Product Advisory (PA)

Subject: Changes to the Power-up / Power-down Sequencing and Recovery from Brown-out Condition **Publication Date:** 2/24/2023 **Effective Date:** 2/24/2023

This notice is to inform you that the High-Performance Serial MRAM Memory datasheet has been updated as follows:

Figure 7: Power-Down and Brown-out Behavior

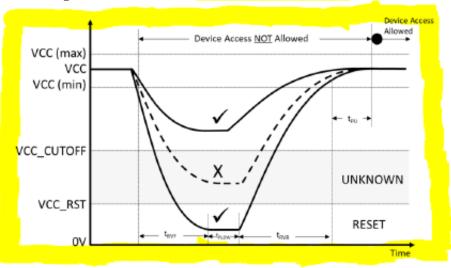
When powering down or in case of brown-out, the following procedure is required to turn off the device correctly:

- Ramp down Vcc below Vcc_Rst level
- CS# must follow V_{CC} during power-down (a 10KΩ pull-up Resistor to V_{CC} is recommended)
- The device must not be selected and that no instructions are sent to the device when V_{CC} is below V_{CC} (minimum)
- The Power-up timing and device initialization needs to be observed after V_{CC} ramps up above V_{CC} (minimum)
- To stabilize the V_{CC} level, suitable decoupling capacitors close to package V_{CC} pin is recommended
- Chip functionality not guaranteed if Vcc ramps down between Vcc_cutoff and Vcc_Rst and then ramps up to Vcc
